March 13, 2019

**Re: Preliminary Comments on the Draft Environmental Impact Report for Contanda Renewable Diesel Bulk Liquid Terminal Development Project (SCH No. 2018102008)**

### Air Basins Affected by the Project

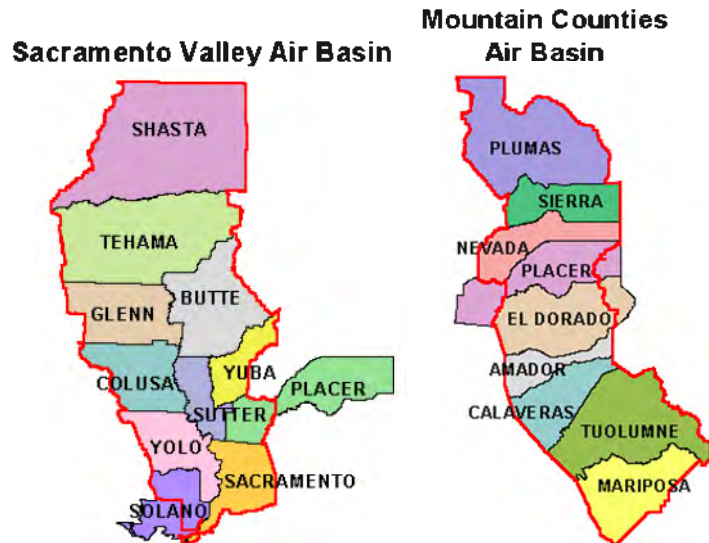
As Dr. Fox explains, the majority of the Project's emissions will be from truck, rail, and ship transport, all of which will pass through up to 20 other air basins, each under the jurisdiction of a different air district, as illustrated below:

Because the DEIR only evaluated emissions from the Project site to the SJVAPCD boundary, or 15 miles for OGVs and 88 miles, one way, for trucks,<sup>63</sup> Dr. Fox concludes that the DEIR fails entirely to disclose or mitigate the emissions resulting from the Project that will occur outside the San Joaquin Air Basin. The DEIR also fails to identify key facts contributing to the nature and extent of emissions, including the source(s) and destination(s) of the product, the route(s) that the trains would take to the Terminal, the destination of the renewable diesel, or the miles traveled in any location other than the hosting air district.<sup>64</sup> These are serious omissions.<sup>65</sup>

Emissions resulting from the Project that occur anywhere in California must be similarly quantified and evaluated, including emissions generated by the transport of materials used during Project construction and operation, and by the outgoing transport of renewable diesel fuel from the Project site outside the hosting air district. The DEIR must be revised and recirculated to disclose Project emissions from all sources within the State.

Revised Health Risk Assessment

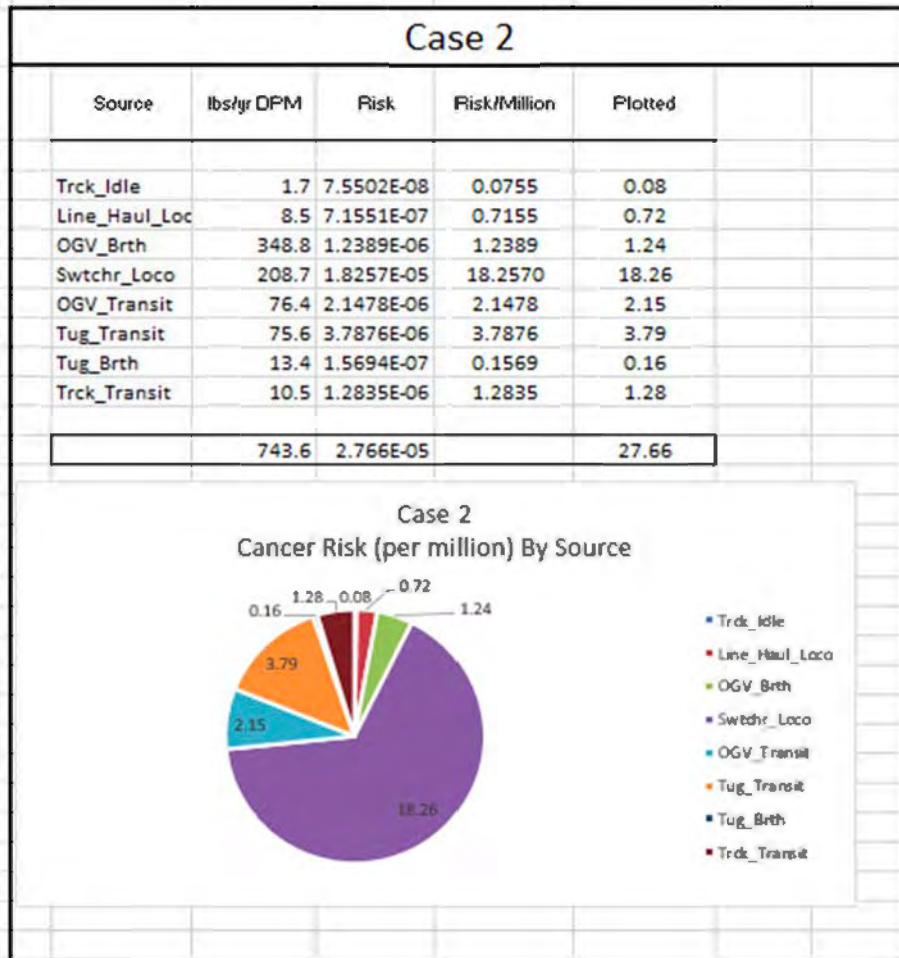
Dr. Fox prepared a revised health risk analysis using recommended agency protocols, corrected emissions factors, and updated modeling assumptions using the Project description contained in the DEIR. Dr. Fox's revised analysis assumes switcher DPM emissions of 208.7 lb/yr (instead of 54.7 lb/yr, modeled in the DEIR) that occur around the clock, and switcher and truck routes adjacent to residential areas, but otherwise retained the DEIR's assumptions.<sup>83</sup>

When modeled correctly, Dr. Fox concludes that the Project's TAC emissions are likely to result in significant health risks from increased residential cancer risk that are not disclosed or mitigated in the DEIR, as follows:

Dr. Fox’s health risk analysis demonstrates that the 30-year cancer risk at the nearest home (receptor #269) is 27.7 per million, compared to the DEIR’s cancer significance threshold of 20 per million.<sup>84</sup> Thus, residential cancer risks are significant.
